Work Order ID 72833

DART SERVICE INSTRUCTION

TO AMEND INSTALLATION INSTRUCTIONS D350-591 REV. G
AND INSTRUCTIONS FOR CONTINUED AIRWORTHINESS ICA-D350-591 REV. 3
REF TCCA STC: SH92-6
REF FAA STC: SH967NE

TO PROVIDE AN OPTIONAL CUSHION KIT TO BE INSTALLED ON THE D350-591-111A/-113/-115/-117A/-119 *Heli-Access-Step™* (THE D2856-400-720 ABRASION STRIP IS REPLACED WITH THE D3595-200-300 CUSHION).

FIGURE 32-9: Crosstube Attachment
REF ICA-D350-591

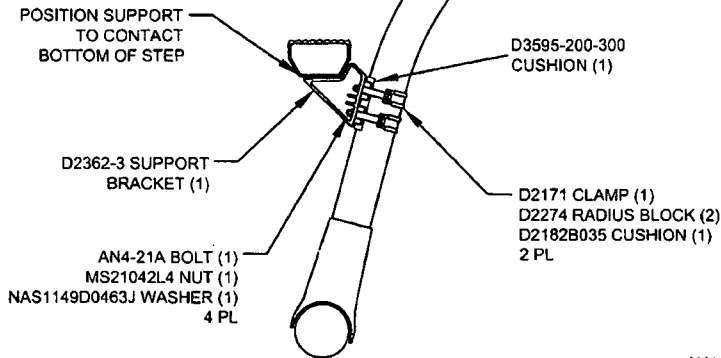
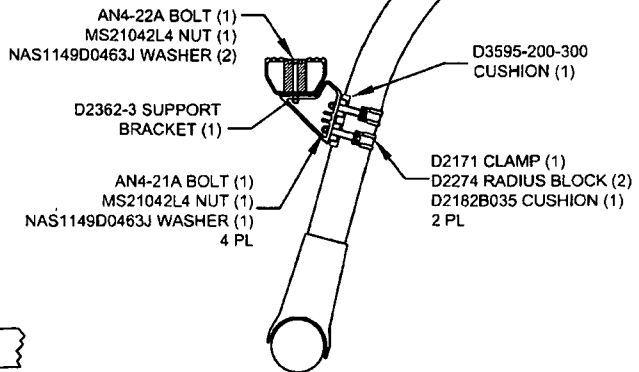
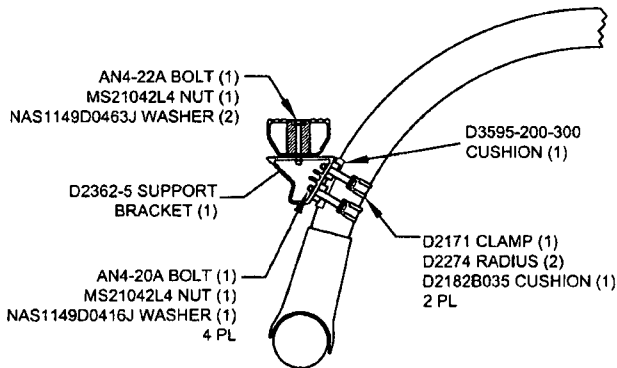
1. REMOVE THE STEP PER ICA-D350-591 SECTION 32.2
2. REMOVE THE D2856-400-720 ABRASION STRIP PER ICA-D350-591 SECTION 32.4
3. POSITION THE D3595-200-300 CUSHION AS INDICATED ON SHEET 3 OR 4 (AS APPLICABLE) OF THIS SERVICE INSTRUCTION.
4. REINSTALL THE STEP PER ICA-D350-591 SECTION 32.1 AS APPLICABLE USING THE NEW HARDWARE PROVIDED AS SHOWN ON SHEET 3 OR 4 (AS APPLICABLE) OF THIS SERVICE INSTRUCTION.
